Name of Proposed Subdivision HARRIS HEIGHTS ADDITION PHASE THREE

**HARRIS HEIGHTS ADD'N PHASE THREE**  
**S.S. McCURRY SURVEY-ABSTRACT 146**  
**ROCKWALL, ROCKWALL COUNTY**

Re: Harris Heights Addition  
Phase III - ROK 84806

Re: Harris Heights Phases I, II, III,  
and IV - Revised Plat

4/26/84

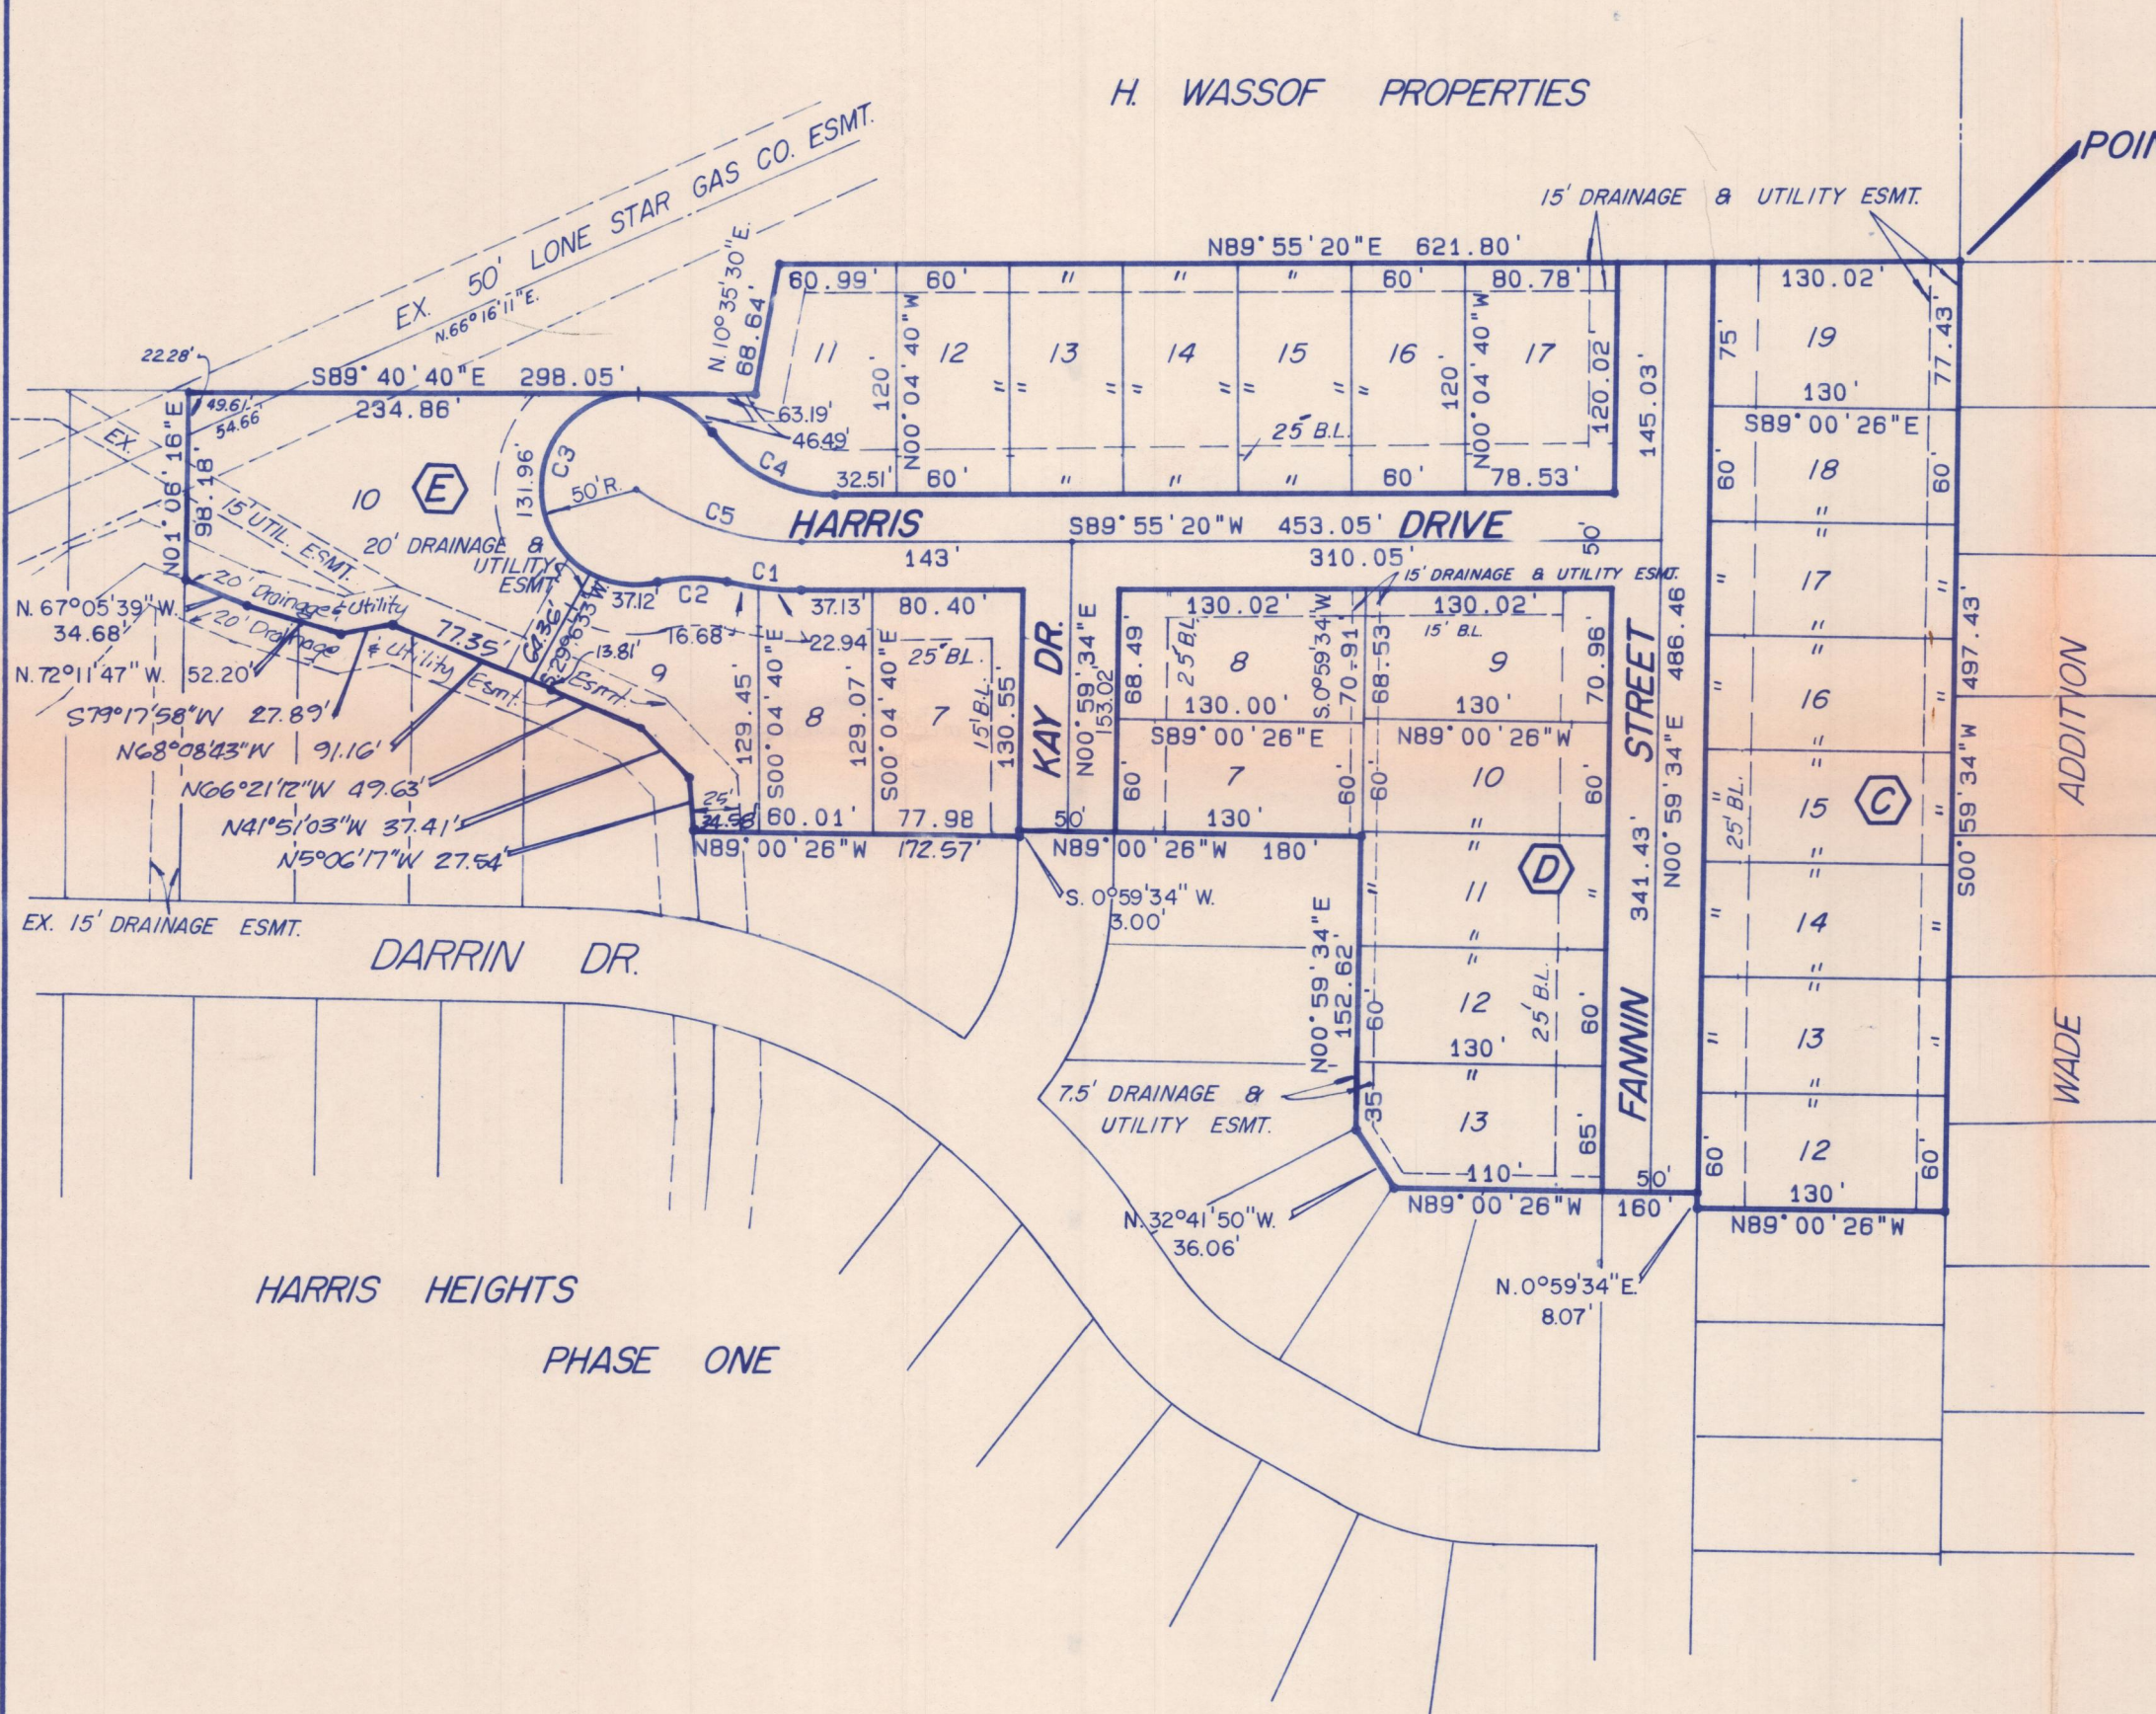
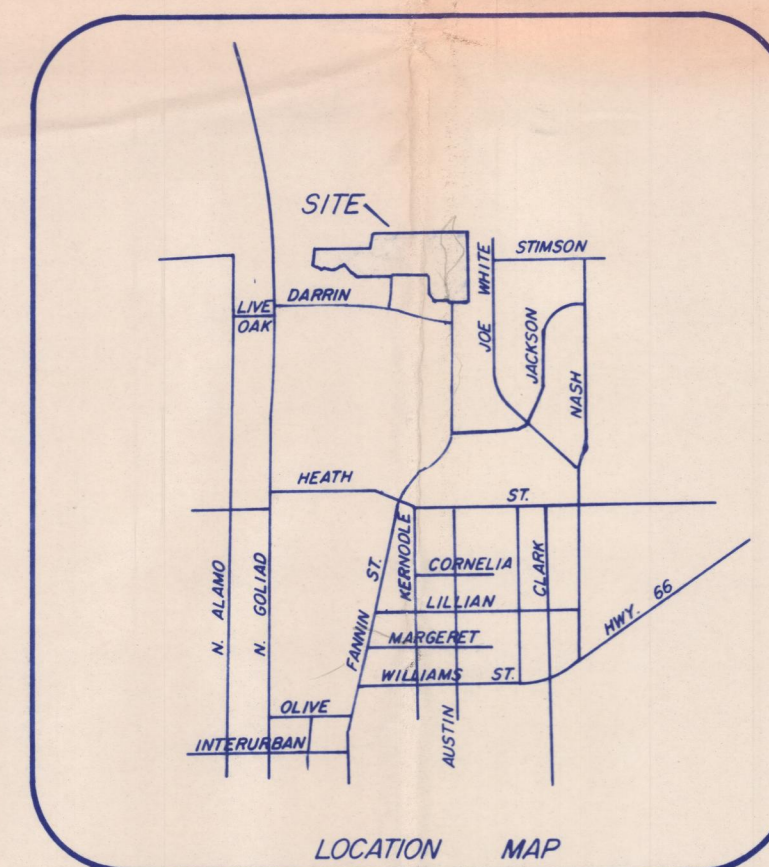
Staff Comments: Harris Circle not a circle. Temporary turnaround needed on Fannin St. Engineering must be resubmitted to Freese and Nichols. The adjacent homeowners in the Wade Addition have expressed concern over drainage. We have instructed the engineers to check it closely. Needs requirement for 6 ft. fence along rear Lots 12-19, Block C.

Planning and Zoning Commission Recommendations:  
4/12/84 - Approved with 6 ft. wood fence on Lots 12 - 19, Block C, Change Circle to Drive, 25 ft. building line and subject to engineering approval.

NOTE:

Before a Certificate of Occupancy will be issued on Lots 12 thru 19, Block C, a 6-foot high wood fence will be constructed by the builder.
